Subj: Comments On Draft NRC Bulletin On Loss Of Fill-Oil In
Rosemount Transmitters

Enclosure 3 to the Minutes of CRGR Meeting No. 179
Proposed Generic Letter on BWR Channel Box Bow Problem
February 7, 1990

PRESENTATION TO CPGR ON
PROPOSED GENERIC LETTER ON
DEFICIENCY IN BWR THERMAL LIMITS
CALCULATIONS CAUSED BY CHANNEL BOX BOW

SUBJECT: REQUEST FOR REVIEW OF A DRAFT BULLETIN ON LOSS OF FILL-OIL IN
TRANSMITTERS MANUFACTURED BY ROSEMOUNT

Figure 1
Channel Bow

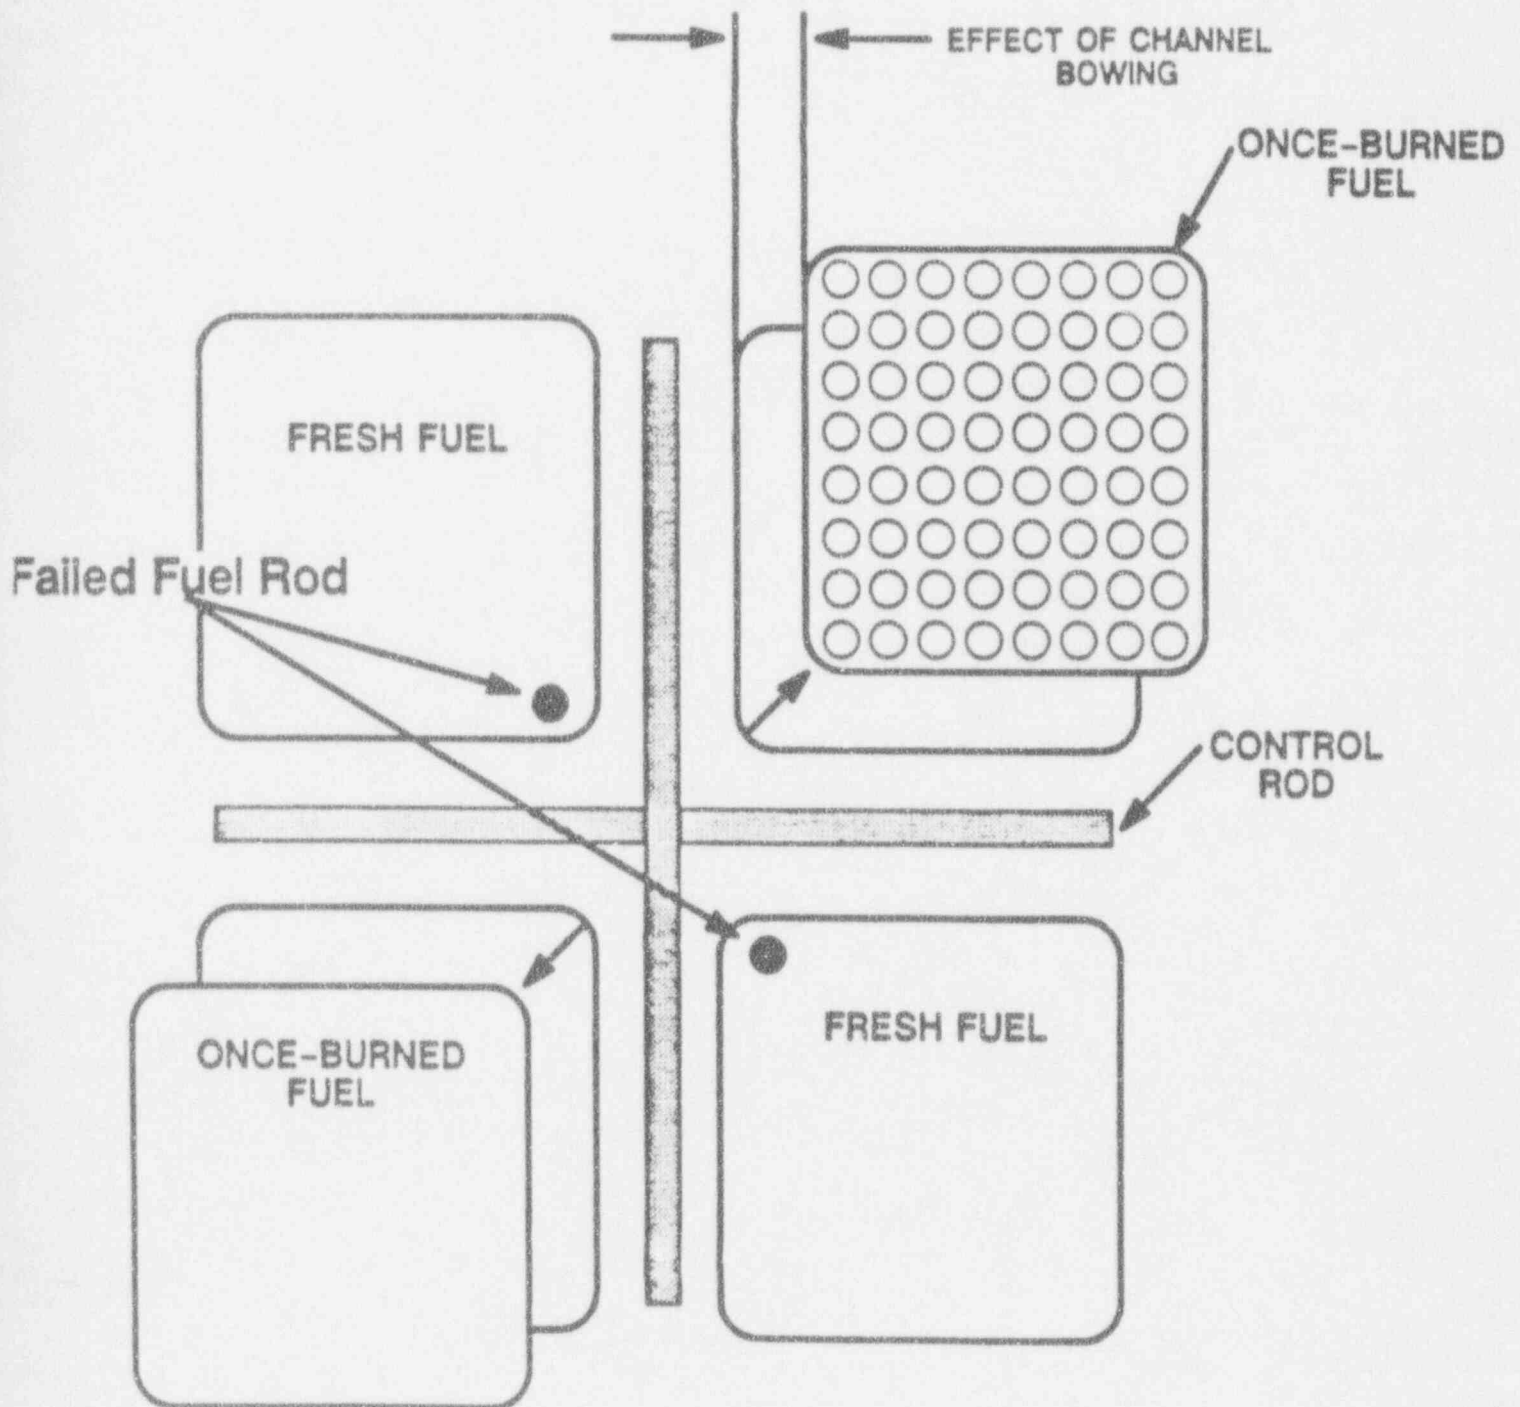
- o EXTENSIVE INVESTIGATIONS LED TO THE CONCLUSION THAT THE FUEL FAILURES WERE CAUSED BY DRYOUT (CLADDING OVERHEATING) CONDITIONS WITH SECONDARY FAILURES CAUSED BY HYDRIDING
- o DRYOUT CONDITION ON FAILED RODS CAUSED BY TWO EFFECTS
 - ° CHANNEL BOX POW GREATER THAN EXPECTED
 - ° INCORRECT MODELLING IN PROCESS COMPUTER OF SVEA-64 FUEL BUNDLES (THIS IS NOT A CONCERN FOR US BWRs)

- ° D-LATTICE PLANTS DELTA-CPR/ICPR UP TO $-.03$
- ° C-LATTICE PLANTS DELTA-CPR/ICPR UP TO $-.02$
- ° ABOVE ESTIMATES ARE FOR SINGLE BUNDLE LIFETIME CHANNELS; IMPACT IS MUCH GREATER FOR SECOND BUNDLE LIFETIME CHANNELS DUE TO ACCELERATED RATE OF BOW

- o ENSURING THAT THE PROCEDURES FOR MONITORING THERMAL LIMITS DURING REACTOR OPERATION WILL PREVENT VIOLATION OF THE MINIMUM CPP OPERATING LIMIT BY THE USE OF AN NRC APPROVED METHODOLOGY THAT TAKES INTO ACCOUNT THE NEW DATA ON FUEL CHANNEL BOWING, OR
- o IMPOSING ON THE OPERATING CPR LIMIT (OR LIMITING CURVE) A CHANNEL BOW PENALTY OF EITHER 0.03 DELTA-CPR FOR D-LATTICE PLANTS OR 0.02 DELTA-CPR FOR C-LATTICE (OR S-LATTICE) PLANTS AND BY REMOVING ANY CHANNEL BOXES THAT ARE BEING REUSED AFTER THEIR FIRST BUNDLE LIFETIME

Figure 1
Channel Bow

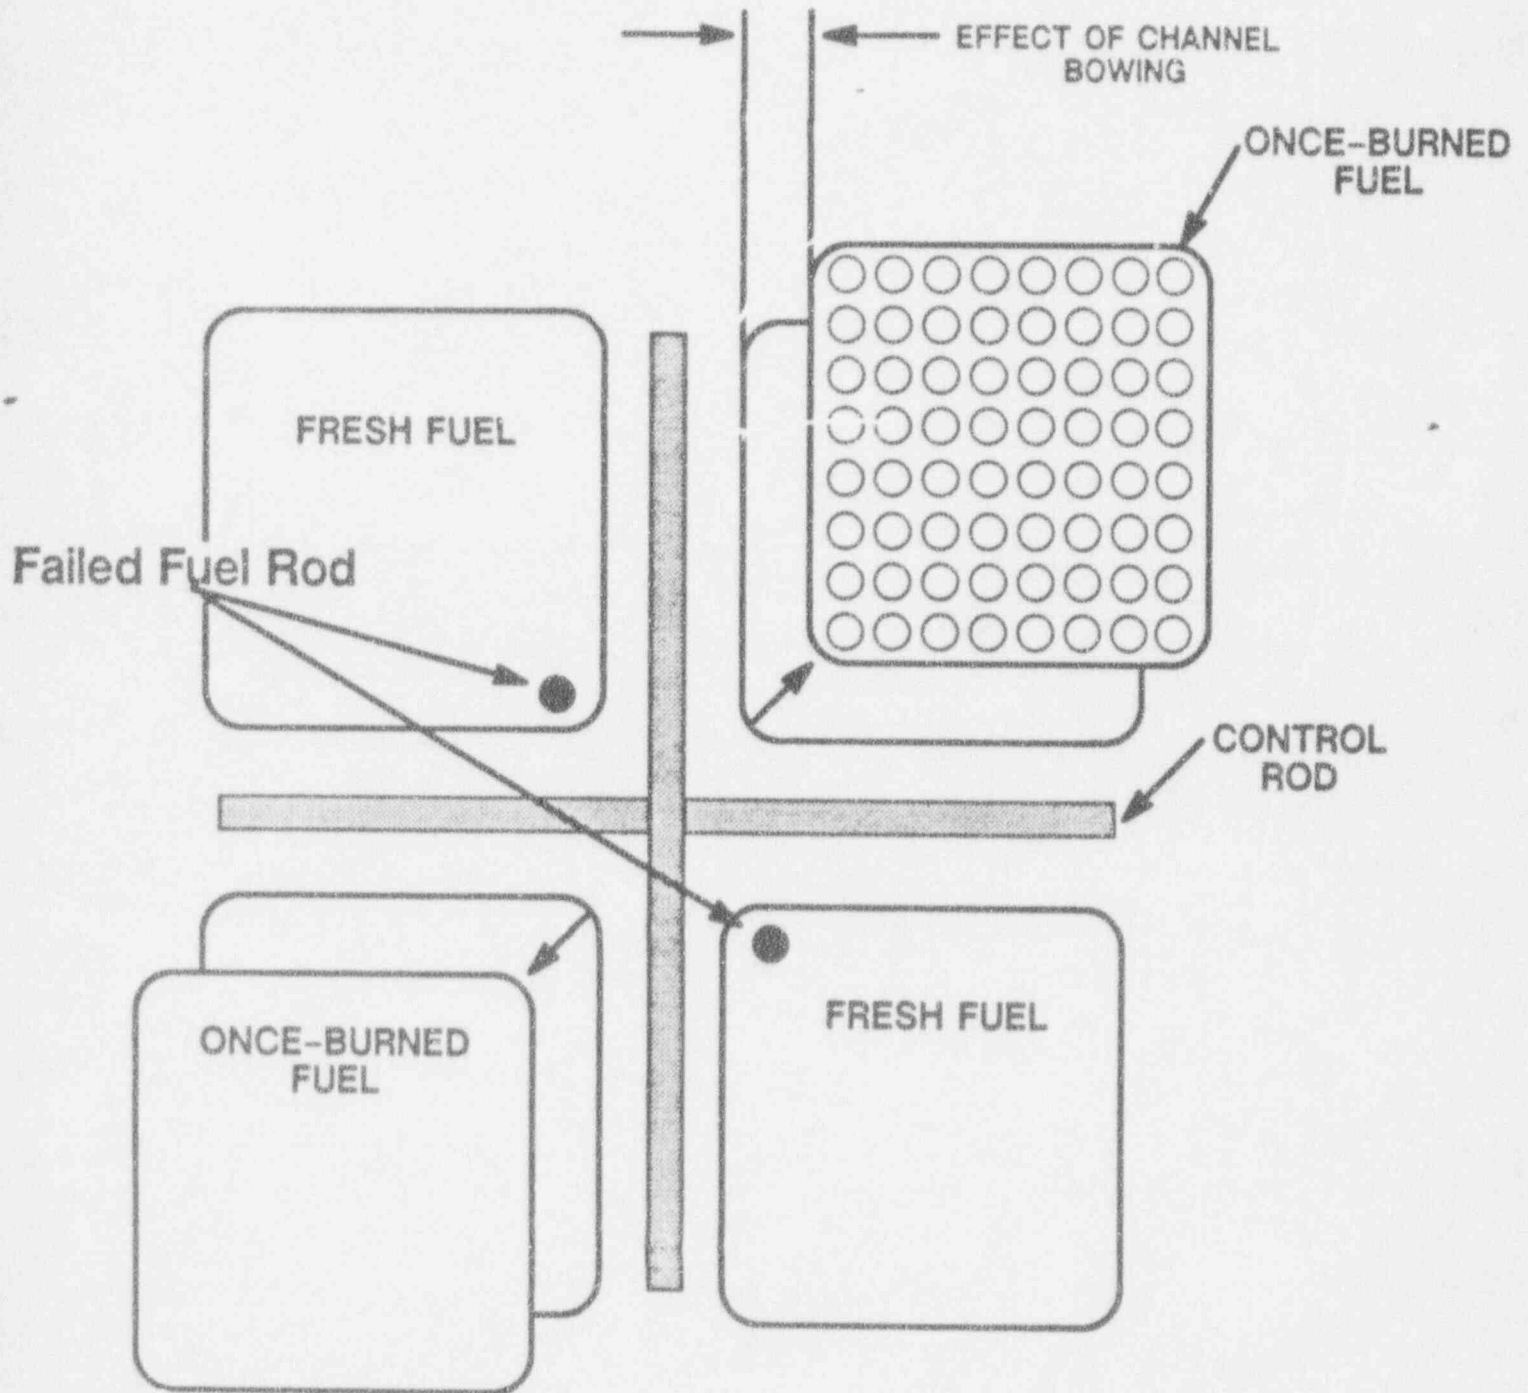
The failed fuel rods were located symmetrically in the core. The fuel assemblies containing the rods that had failed were located adjacent to once-burned fuel assemblies with highly exposed fuel channels (see Figure 1). These fuel channels were in their second bundle lifetime and had excessive channel bowing. In each assembly with failed fuel, the corner rod facing the adjacent control rod was heavily oxidized and the cladding was penetrated just below the top spacer grid. In addition, each of the four failed rods had typical secondary internal hydriding damage near the bottom of the fuel rods, resulting in loss of fuel material.

Dryout of the fuel rods in this foreign facility occurred because of modeling errors in the plant process computer, which resulted in nonconservative calculated values of the minimum critical power ratio (MCPR) of the core. These

modeling errors were caused by neglecting the effects of channel bowing and the geometric variation between the reloaded and once-burned fuel assemblies. These effects substantially increased the widths of the control rod water gaps for the assemblies that contained these four fuel rods beyond that assumed in the plant process computer calculations. The increased neutron moderation associated with the increased water gap widths led to very high localized power peaking at these four fuel rods. However, these effects were not properly accounted for in the MCPR calculations. For some time, the plant operators were misled by these erroneous MCPR calculations and were operating the plant in steady-state beyond the MCPR safety limit.
